Vancouver Art Gallery North Plaza Redesign: Consultation Summary

The purpose of this report is to provide a summary of what was heard during the consultations on the VAG North Plaza redevelopment. This summarizes results from the two Open Houses, online questionnaire and stakeholder meetings.

CONCEPT DESIGN - OPTION 1 - WET VANCOUVER ART GALLERY NORTH PLAZA REDEVELOPMENT

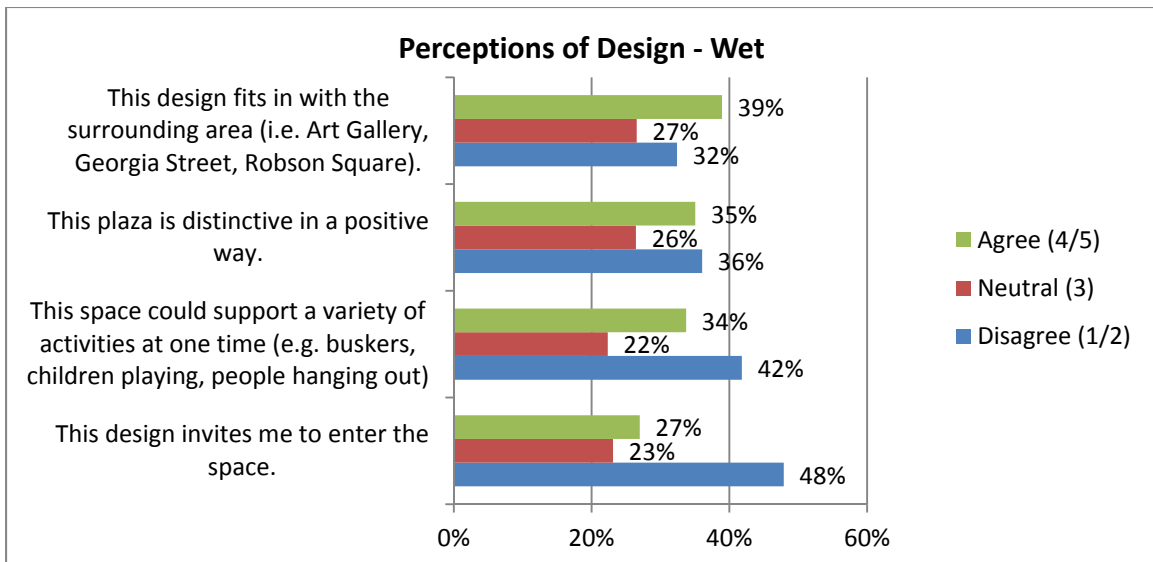
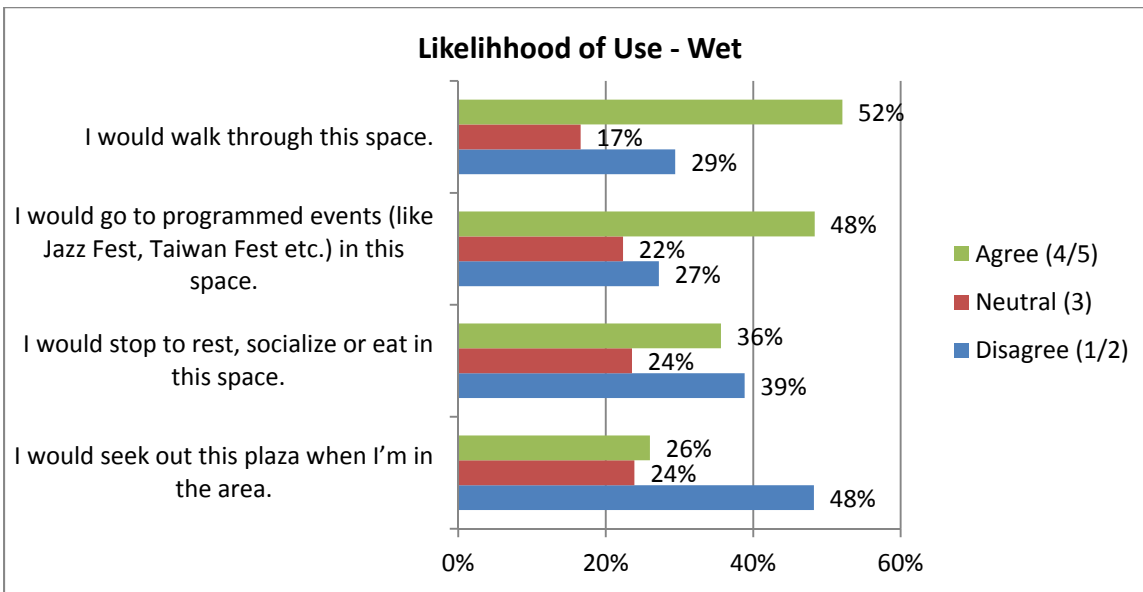
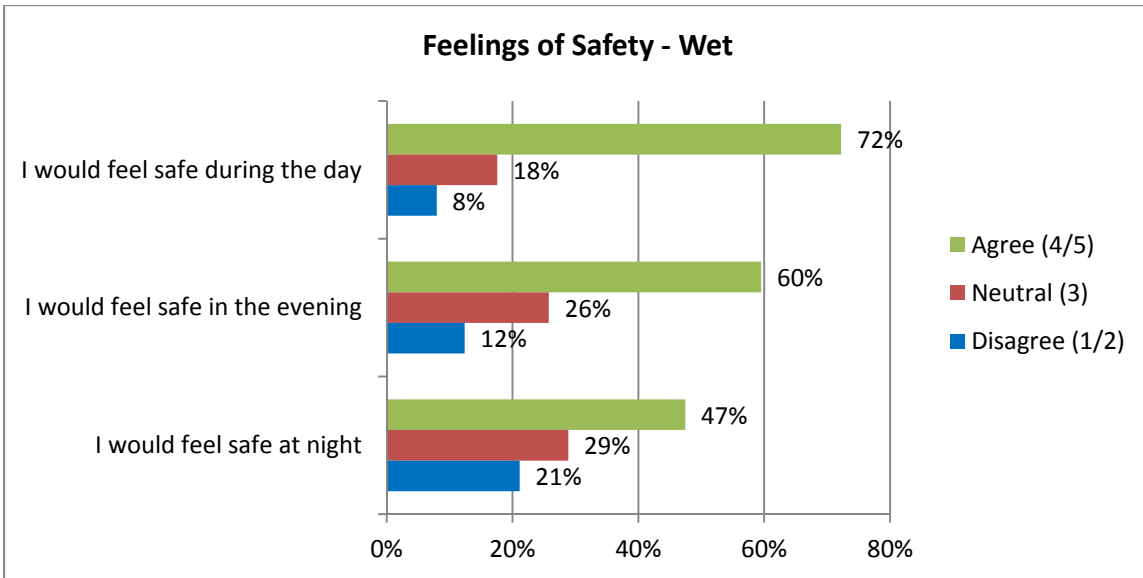
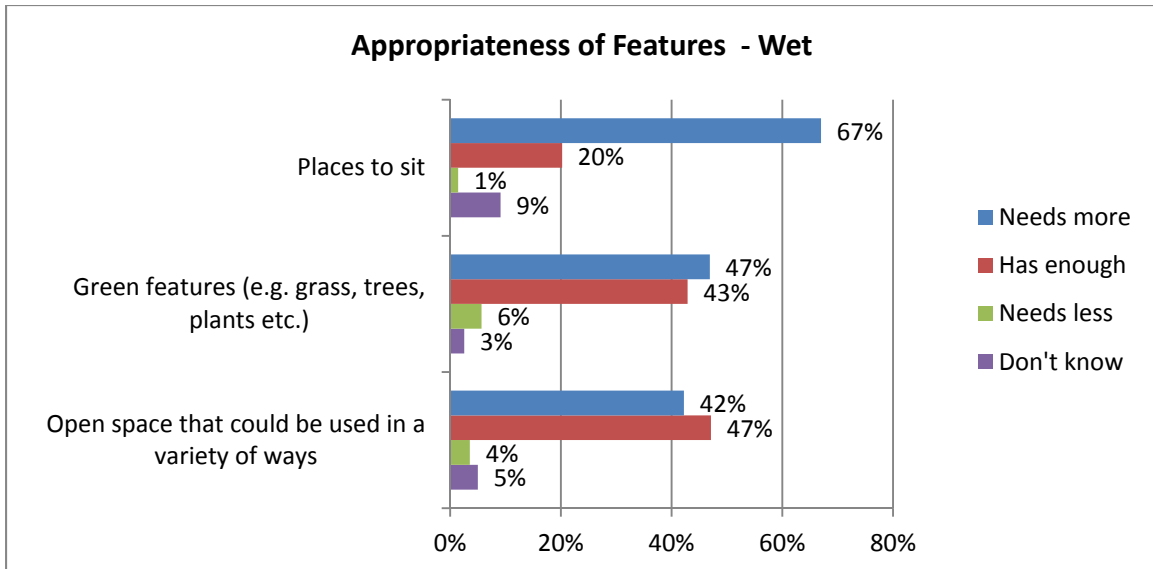
- Was playful. Children would like this design
- Celebrated the climate
- The trees

- The openness
- Use of water to reflect the building
- Flexible - variety of uses, have a lot of different types of event
- Elegant, simple
- Unique and engaging

- Vancouver is wet enough already
- Hazardous - concern that it could be slippery and be a tripping hazard (especially for seniors)
- You would get wet feet from walking through water - “will I need rain gear to walk through”?

- Too many puddles

- Not enough seating
- Not appropriate for business shoes
- What happens when it freezes in winter
- Impractical
- Confusion as to how it would work
- Upkeep/operating costs
- Bland/not unique
- Water feature too large, took up too much of the plaza
- Too empty and vacant
- Discourage gatherings -- Concern that there's the potential to flood out protests
- Too many trees on Hornby (made it dark with too much of the canopy, wouldn't be able to see the Hotel Vancouver as well)
- Not green enough
- Want more trees on Howe

I don't really understand it -- where does the water come from -- where does it go when the jazz festival is on?

Vancouver is wet enough as it is. Some people would say this design celebrates the rain, but personally - I think it would remind me how much I don't like the rain. I don't like feeling wet and cold. The only way I'd be able to participate in the wet 'puddle' activity was if I bought myself good rain gear. Rain gear is incredibly expensive, and I'm not able to afford good rain gear right now.

The north plaza is the key gathering spot for civil democratic gatherings in the downtown core. This function absolutely should be preserved. Deliberately allowing the area to flood would discourage gatherings and make it much less useful.

- Seating
- Art
- Circulation and crossing the space - concern that the design would cut off the natural desire lines in the plaza

- Vegetation (planting, trees)
- Open space for gathering
- Food & beverage
- Way to define the edge -- through seating
- Covered space/shelter
- Smaller scale for interactions

CONCEPT DESIGN - OPTION 2 - ACTIVE EDGE

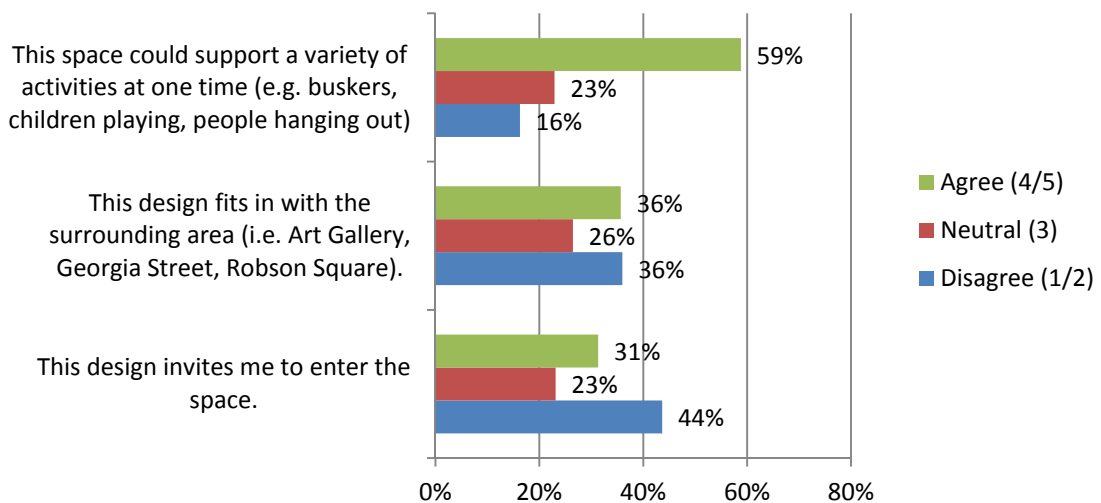
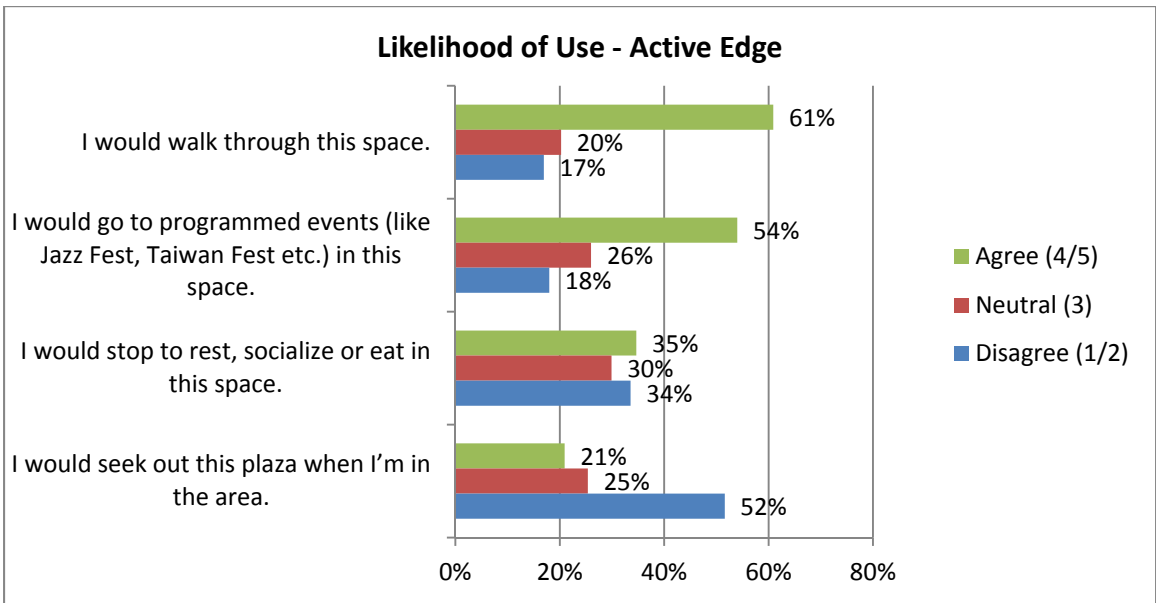
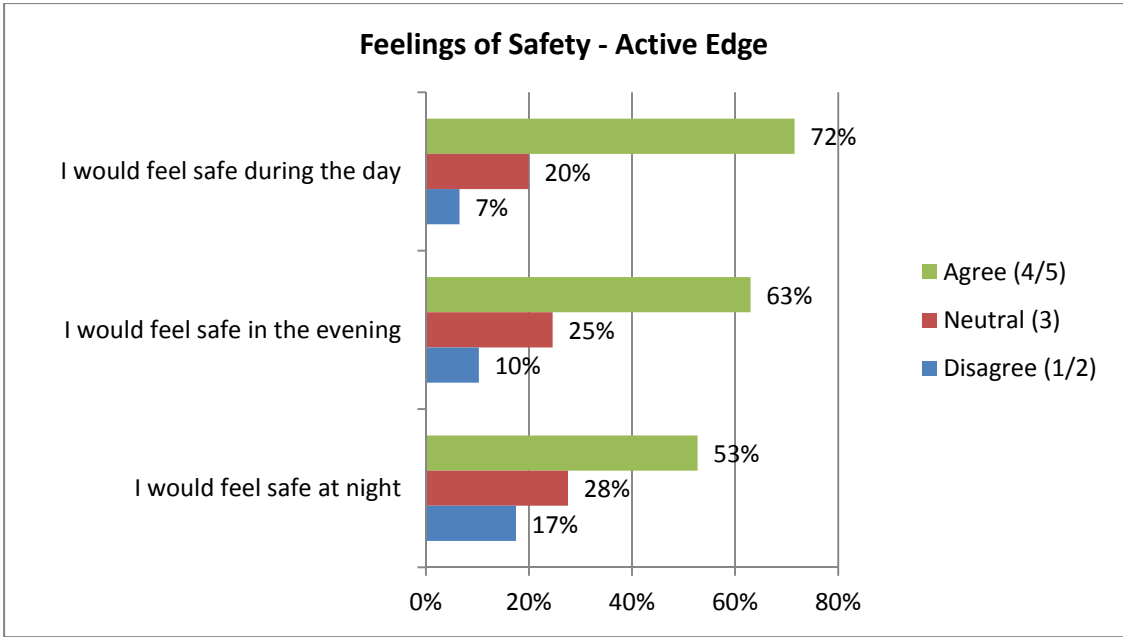
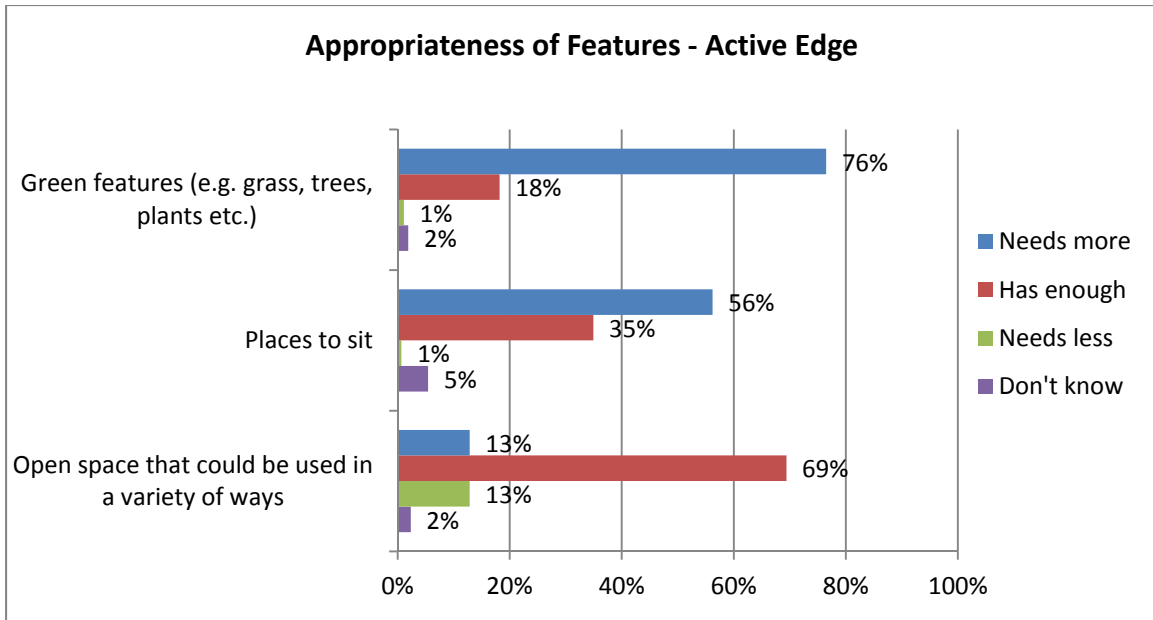
- Nothing
- Edge on Georgia
 - Separation
 - Sound buffer
- Openness
- Flexibility of space
- Open and modern

- Covered cafe seating -- kiosk
 - being out of the rain, having a space to gather
- Water feature

"This design is very flexible, it enables connections, and it has good scale. It's easy to gather and move through the space without impediments. I like the idea of public wifi here. It reinforces a focus on the art gallery building. The bench by the water feature is a nice length" [sic]

- Sterile -- too corporate, office plaza, a parking lot
- Too barren
- Boring

- Not enough green space

- Not enough seating
- Don't like the water feature
- Little character, not inviting
- Separation from street -- couldn't see from the street
- We could do better

- Sense of invitation
- Seating

- Something unique
- Relief from the hardscape
- Art
- Greenery More trees along Howe street
- Areas for groups of people to hang out
- More covered area

*“Some relief from the relentless hardscape, a more interesting paving pattern, at least”
[sic]*

“something to draw you to the space” [sic]

CONCEPT DESIGN - OPTION 3 - PLALO RING

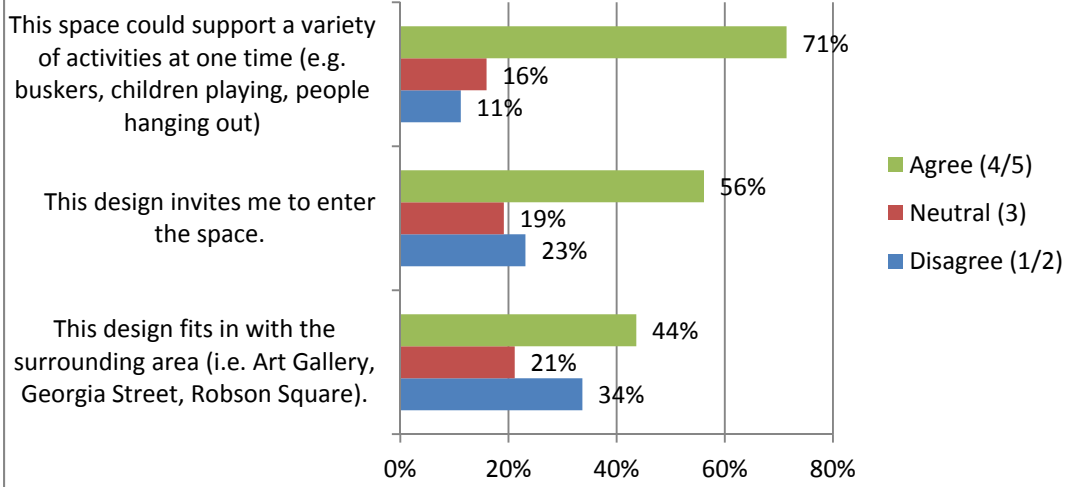
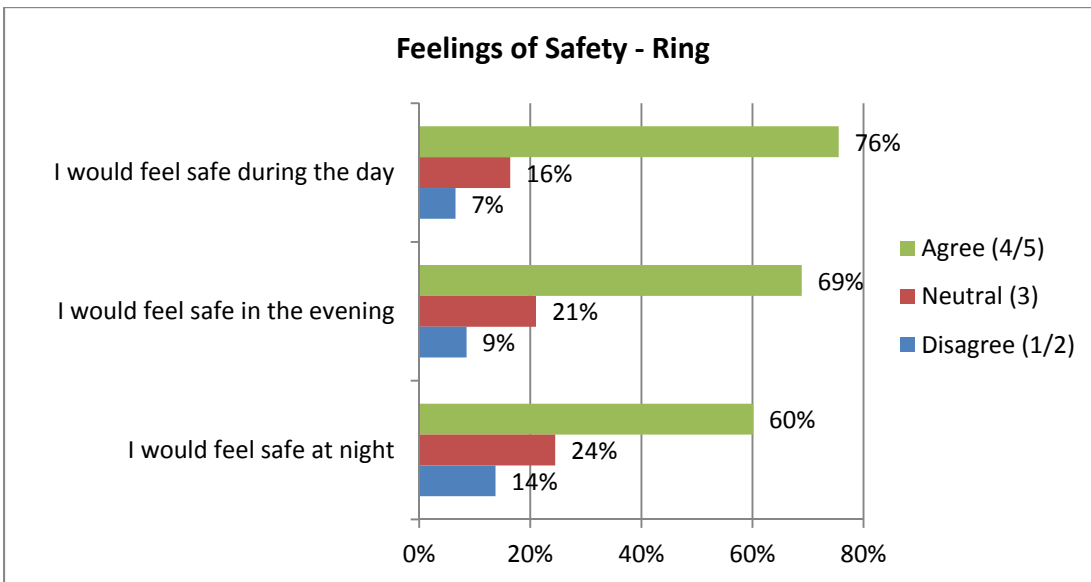
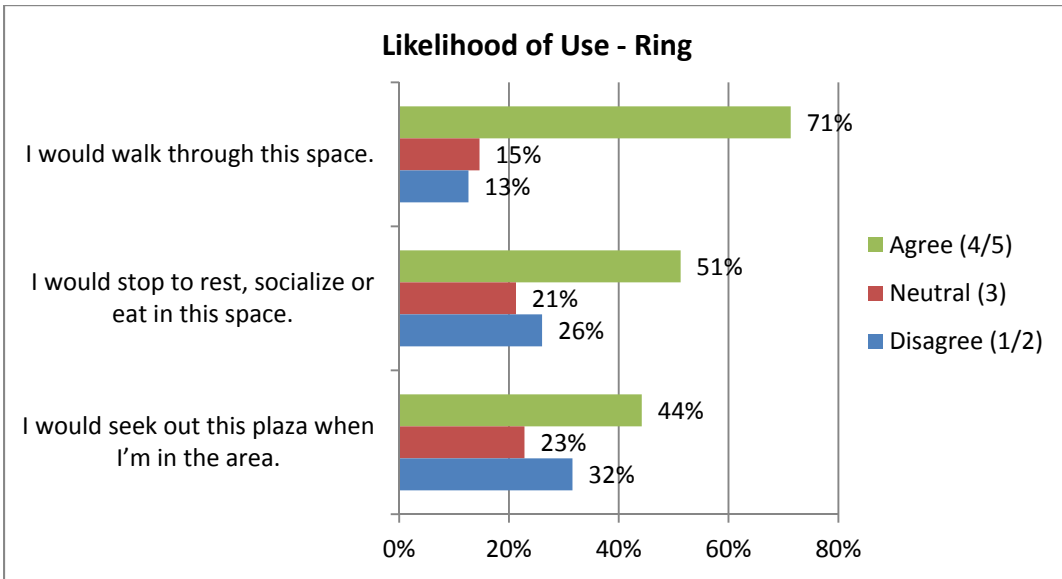
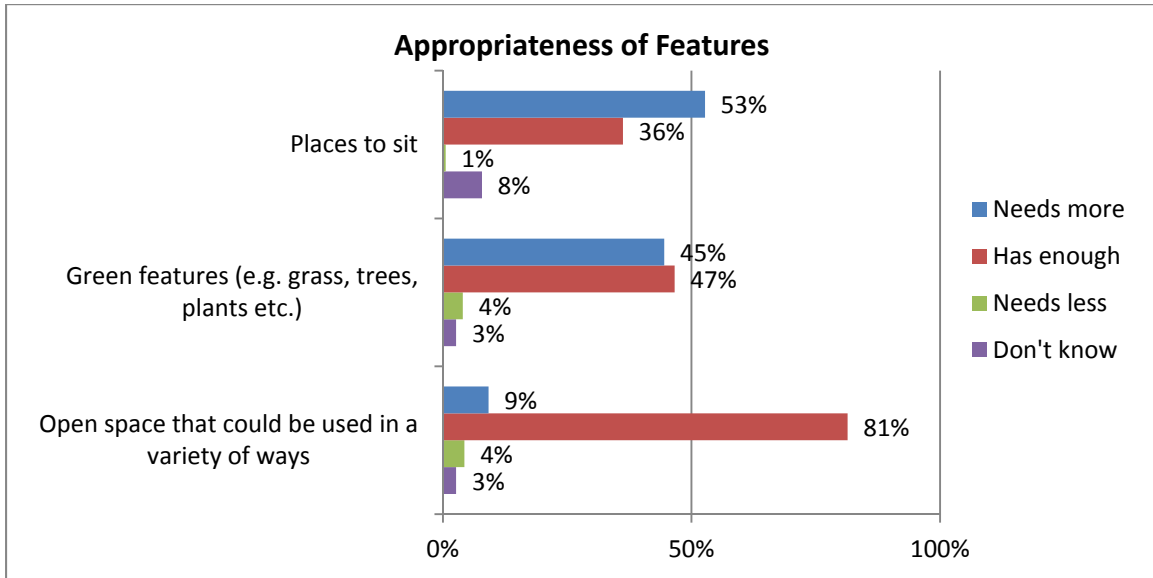
- The Ring - dramatic, unique, artistic feature, recognizable,
- Distinctive - sense of notoriety
- Iconic design

- Playfulness
- Trees
- Openness
- Balance between the hardscape and greenery
- Versatility
- Lighting
- Warm, inviting, accessible

“The ring ...at first I wasn't sure however it's grown on me. Very unique ...it would really set us apart locally & internationally! Makes it more night friendly too! I think it makes it a destination space such as the Laughing Statues on English Bay. It would make people smile!” [sic]

- The Ring - worried it would look tacky, gimmicky, tired, too trendy,
- Safety - what happens in high winds? earthquake? ice?
- Concerns that it does not fit with the existing site and the Art Gallery building

- Maintenance
- Cost/expense
- Little seating
- Too many trees
- Birds
- Would get dated

“Very unsafe having a floating structure above you at all times, in all weather, winds, storms. Takes away from facade of the Art Gallery Building” [sic]

- Seating
- Greenery

- Edge definition - especially along Georgia Street
- Water feature
- Shelter
- European feel
- Cafe
- Patterns in the plaza
- Natural materials

“I think it lacks some low lying, interspersed greenery/landscaping along the Georgia street boarder, simple to define the boundary and provide some relief from all the paving (street to sidewalk to plaza). In addition to purpose-built benches, landscaping elements/retaining walls, etc can be used to accommodate seating for events, activities, picnics etc. Having less formalized seating can attract the casual observer.” [sic]
